Type of Report: Committee
Council: 7 May 2018
Expiry Date: 24 May 2018
Application No: PLN-17-979
Address: 2 DAVIES AVENUE , HOBART
Applicant: Leigh Knight (pitt and sherry)
PO Box 1409
Proposal: Partial Demolition, Works and Lighting
Representations: Two (2)
Performance criteria: Recreation Zone Development Standards, Potentially Contaminated Land Code, Historic Heritage Code

- 1.1 Planning approval is sought for Partial Demolition, Works and Lighting at Soldiers Memorial Oval on the Queens Domain.
- 1.2 More specifically the proposal includes:

Fig. 6. Plan showing the two light towers to be demolished. Source: Pitt and Sherry *Report to Support a Development Application*.

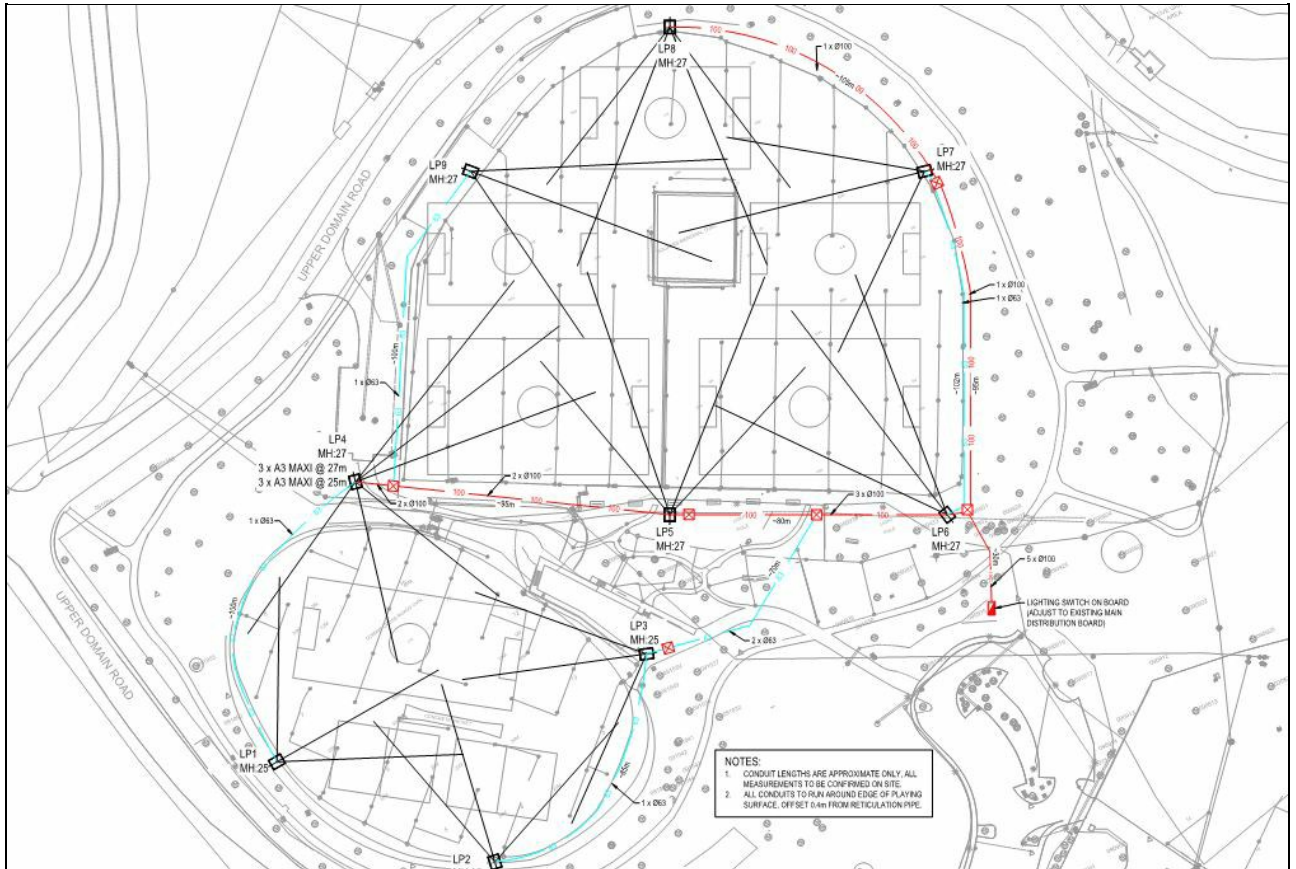
The following light towers have been relocated from between trees planted for the Soldiers Memorial Walk: LP1 (25 metres high), LP2 (25 metres high), LP7, LP8 and LP9 (all 27 metres high). They are now in new locations and located between the inside row of the avenue and the edge of the playing surfaces. The location of the remaining light poles LP3, LP4, LP5 and LP6 have not been changed and are located outside the Soldiers Walk.

The amended consultant's report in regards to an assessment of the proposal against the provisions of the Queens Domain Cultural Landscape Precinct falls short, however, that aside, the applicant has acknowledged the problem with the previous locations of the light poles in relation to the Soldiers Memorial Avenue and rectified the situation with the revised locations. The applicant has also commissioned an arborists report addressing any potential impact on nearby trees and tree protection zones. An on-site meeting between parties assisted in arriving at this revised plan. The new locations reduce the visual impact of the light poles within the avenue.

When assessed against the provisions of section E.13.9.2, it is considered that the proposal for the design and siting of new light poles will not result in detriment to the historic cultural heritage significance of the precinct, thereby satisfying clause E.13.9.2 P1.

It is recommended that a condition be applied should a permit be issued requiring the installation of barriers around individual trees near the light tower sites marking out the tree protection zones of each tree nearby with the advice of an arborist to avoid soil compaction in general.
